**CITY OF BLOOMINGTON  
PLAN COMMISSION AGENDA  
October 7, 2013 @ 5:30 p.m.**

**BLOOMINGTON PLAN COMMISSION  
STAFF REPORT  
Location: 339 S. Dunn St**

**BLOOMINGTON PLAN COMMISSION  
STAFF REPORT  
Location: 306 E. Kirkwood Ave.**

**A1**

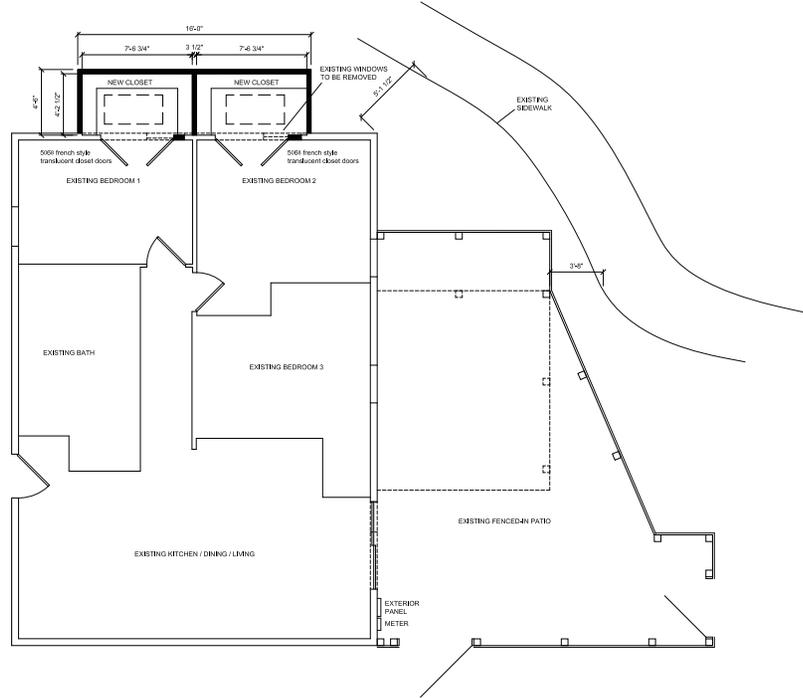
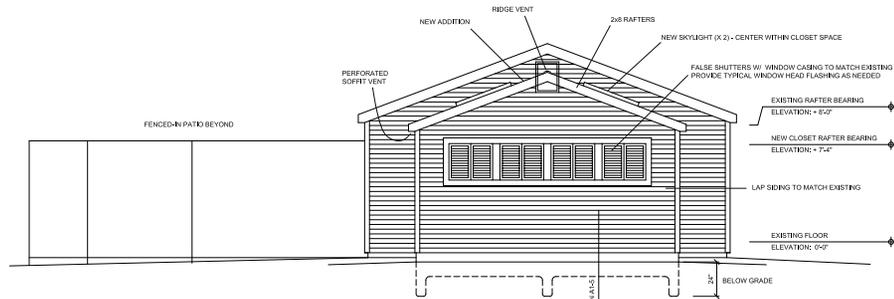
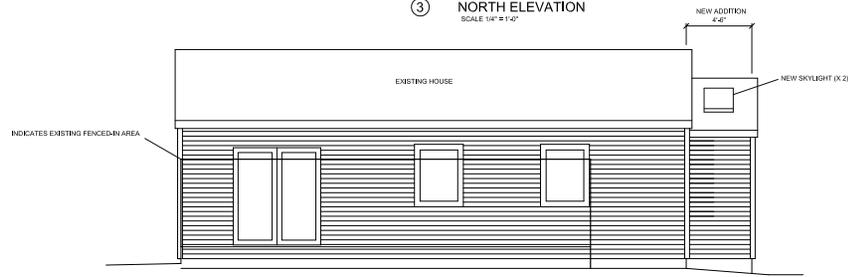
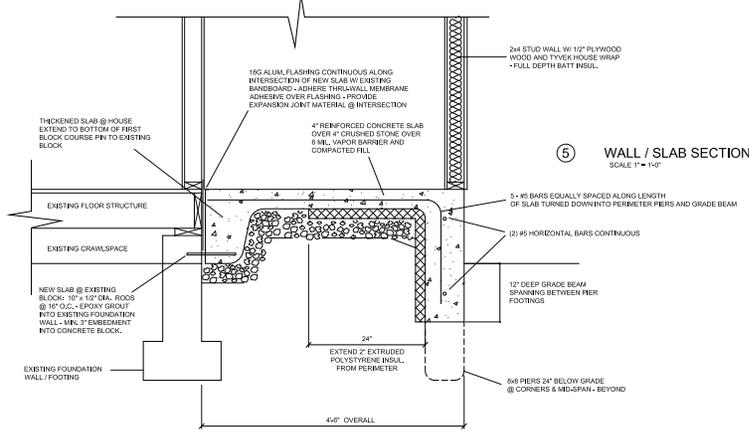
The proposed addition to the north side of the residence would extend 4 feet 6 inches from the existing house and be 16 feet long. The existing residence is approximately 9 feet from the north property line and the proposed addition would be located 4 feet 4 inches from the property line, which would be considered a side yard for building setbacks. The addition would allow for two new closets to be added as well as new skylights in the bedrooms. The addition would have lap siding to match the existing residence and have a row of false windows along the exterior wall facing Atwater Ave.

**Architecture/Design:** There are no architectural or design requirements for the pergola. The addition to the single family residence would be finished with lap siding to match the existing house. The petitioner has added a set of false windows along the north side of the house to prevent a blank wall facing Atwater. Since the proposed additional area is for closet space, actual windows would not be practical. The proposed addition also has two skylights in the bedroom areas that would provide additional interior light in the closet and bedroom.

1. The addition must be consistent with the submitted elevations.

SHEET NUMBER <b>A5</b>	
SHEET DESCRIPTION <b>NORTH ELEVATION</b>	
PROJECT NO. <b>13018.02</b>	DATE <b>9/23/2013</b>
GMS-PAVILION PROPERTIES, LLC. PAVILION CENTER ON KIRKWOOD BLOOMINGTON, INDIANA

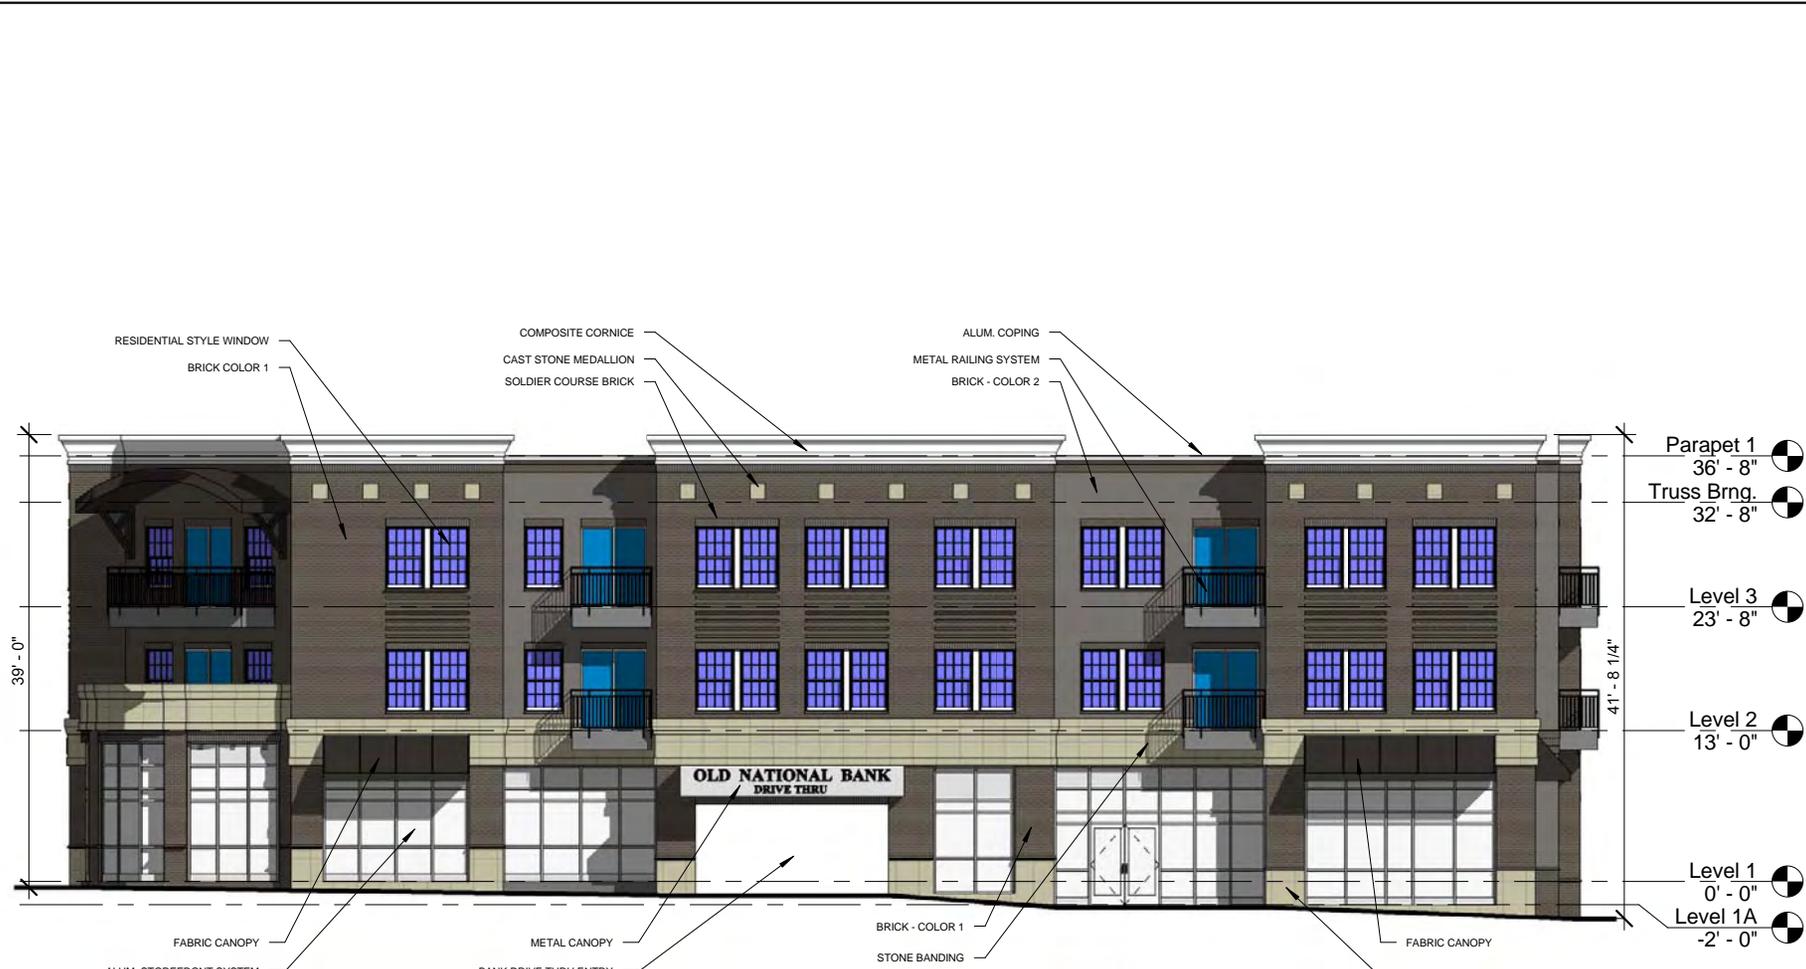
- **First floor commercial percentage:** 50% required, 78% proposed
- **Materials:** The proposed building contains a combination of two colors of brick and a man made "cast stone." Both are permitted materials. Staff has received commentary from one Plan Commissioner who believes the use of cast stone for such an important building on Kirkwood Avenue is inappropriate.

The petitioner correctly notes that the requested height waiver is not the result of additional stories, and that previous waivers have been granted to other projects based on grade issues. However, in Section 20.03.210 of the UDO, the Plan Commission is clearly enabled to utilize the *entirety* of the Downtown Vision and Infill Strategy Plan in the granting of waiver requests. As noted earlier in this report, the overall proposal is not consistent with the Downtown Plan, particularly as a critical addition to the University Village Character Area. As a result, staff does not support this height waiver.

SP/UV-34-13  
 First Floor/Site Plan

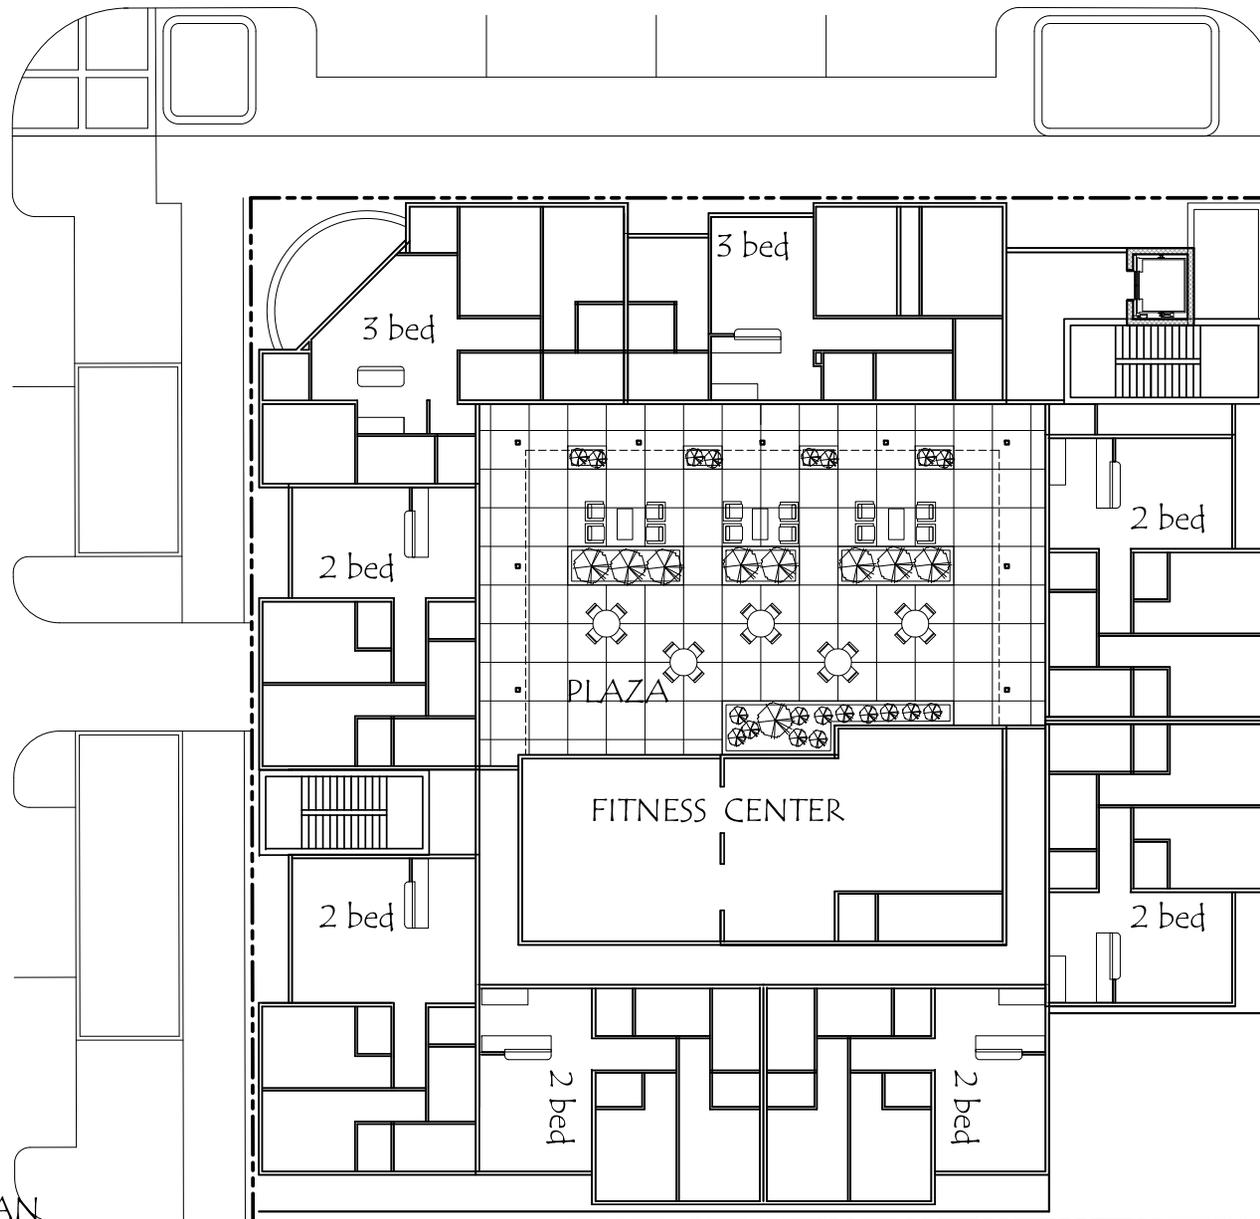
**Use Variance Request:** As noted earlier in the report, the petitioner is requesting to utilize an internal drive-through use for the proposed first floor bank. Drive-throughs are not a permitted use in the CD zoning district and create the need for Use Variance. If the Plan Commission denies the Site Plan as recommended by staff, the Use Variance request

**Growth Policies Plan:** The Growth Policies Plan states that new surface parking areas and drive-through uses should be limited, if not forbidden, within the Downtown area. Staff believes that the intent of this policy is to reduce the dependency on cars in the downtown area and to create a more walkable and pedestrian-friendly downtown environment. The petitioner has done a sound job in minimizing the access impacts onto the surrounding street network. While there is a street cut introduced onto Lincoln Street, the disruption to pedestrians is minimized by the one way nature of the access and the outlet into the north-south alley.

It is an important policy decision to allow even an indoor drive-through facility into the University Village Overlay, particularly for a property located on Kirkwood Avenue. Drive-through uses, regardless of how well they are designed, do limit the amount of usable retail space that can provide energy and maximize the pedestrian experience. This is a more important policy decision for the Kirkwood/Lincoln intersection than for North College Avenue, where such uses have been previously allowed through variance approval. With the right petition, staff might support a drive-through use utilizing side street and alley access as a means to facilitate the relocation of a key downtown anchor like Old National Bank. However, with the Site Plan being inconsistent with the Downtown Plan and the proposed drive-through use clearly linked to the quality of the overall proposal, staff recommends forwarding a negative recommendation to the BZA on the proposed drive-through use.
